CNL-21-020

Subject: **Browns Ferry Nuclear Plant, Units 1, 2, and 3 - Application Requesting NRC Prior Approval of a Proposed Chilled-Water Cross-tie Modification to Support System Operability (BFN-TS-518)**

Browns Ferry Nuclear Plant (BFN), Units 1, 2, and 3 - Application Requesting NRC Prior Approval of a Proposed Chilled-Water Cross-tie Modification to Support System Operability (BFN-TS-518)

Figure 1 BFN Control Bay Cooling Supply Configurations

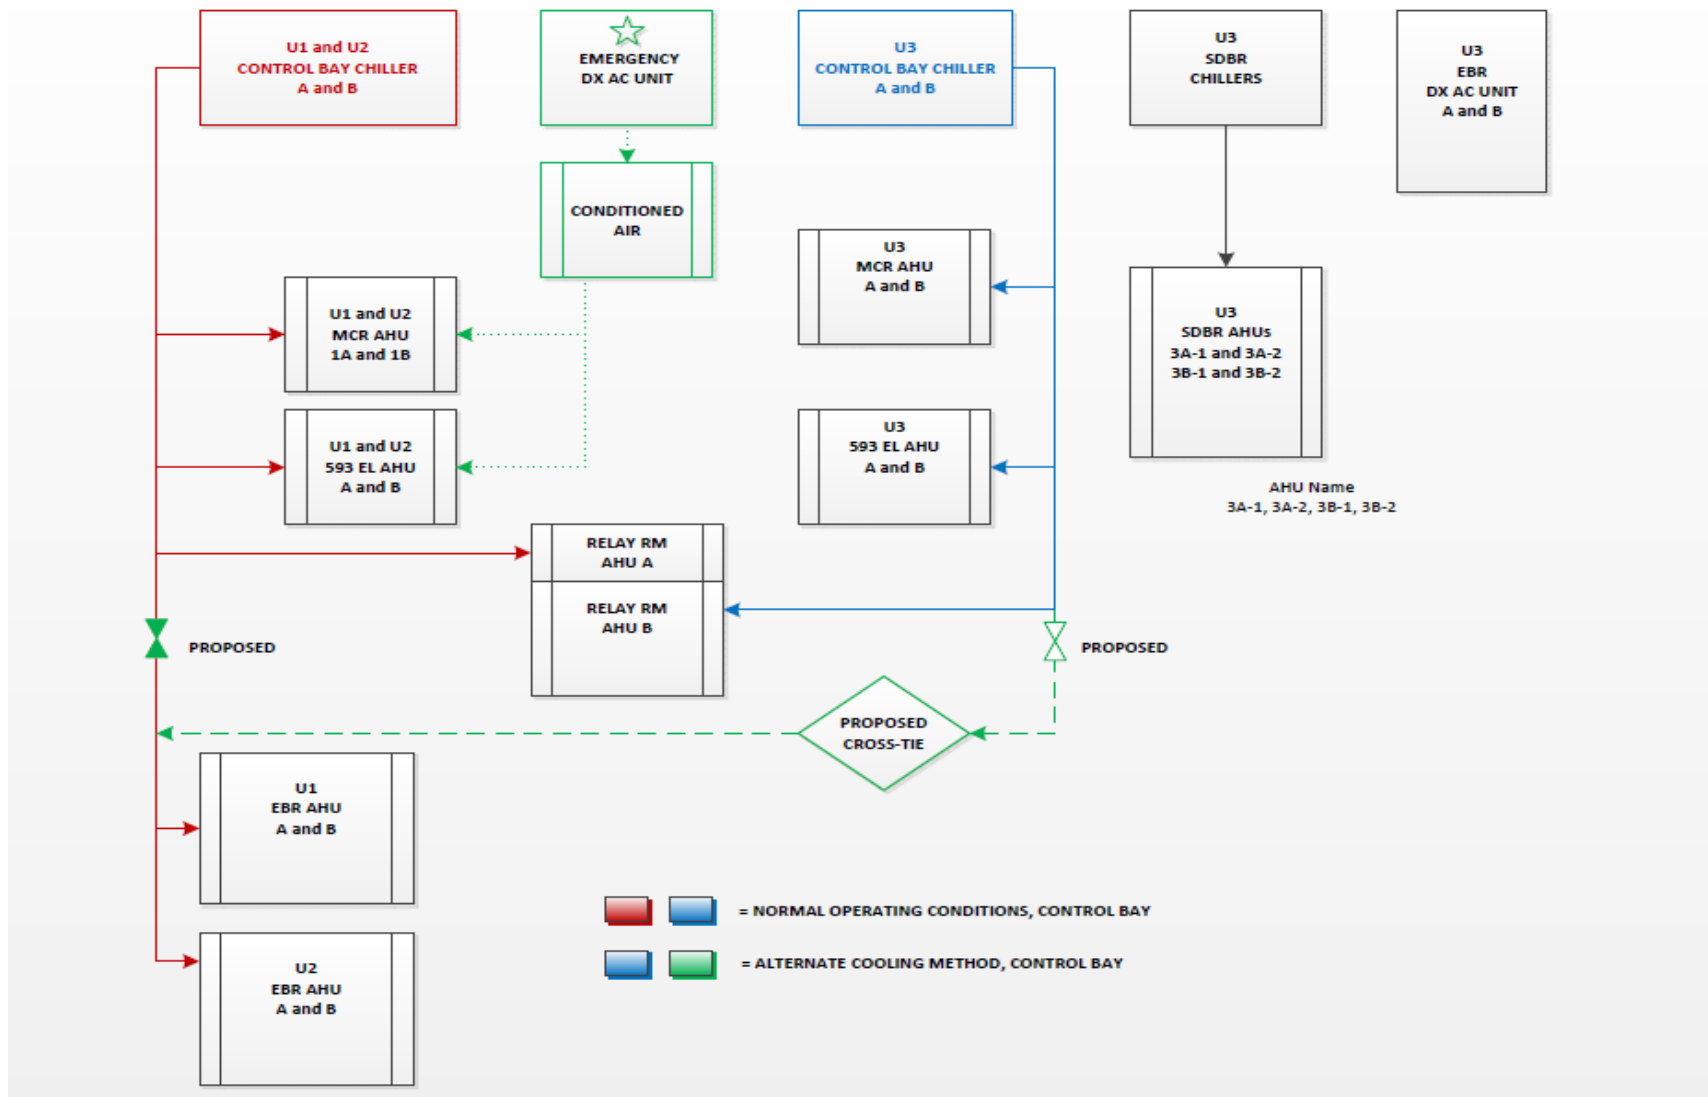
TVA proposes to install a manually operated chilled water cross-tie line from the Unit 3 CB chilled water system to the Unit 1/2 CB chilled water system to be used in the event of an abnormal condition when both trains of the Unit 1/2 CB chilled water system are inoperable. This cross-tie line will meet the same seismic requirements as the current chilled water system piping, which is Class I seismic where appropriate. Operation of this cross-tie line will be performed by operations personnel when the Unit 1/2 CB chilled water system is inoperable (i.e., not providing sufficient chilled cooling water for its equipment loads). A simplified drawing of the proposed modification is provided in Figure 1.

When the cross-tie is in use, the Unit 3 CB chilled water system will supply the Unit 1 and Unit 2 EBR AHUs in addition to its normal loads. Note that, as shown in Figure 1, the Unit 3 4kV and 480V shutdown board rooms are independently cooled by their own chilled-water or air conditioning system. The other Unit 1 and Unit 2 loads not served by the cross-tie, excluding the common switchyard relay room, which is already served by the Unit 3 CB chilled water system, are supplied by emergency direct expansion units when the Unit 1/2 CB chilled water system is unavailable. The emergency direct expansion units have a safety-related power source, are seismically-qualified, and have periodic preventive maintenance performed to maintain functionality.
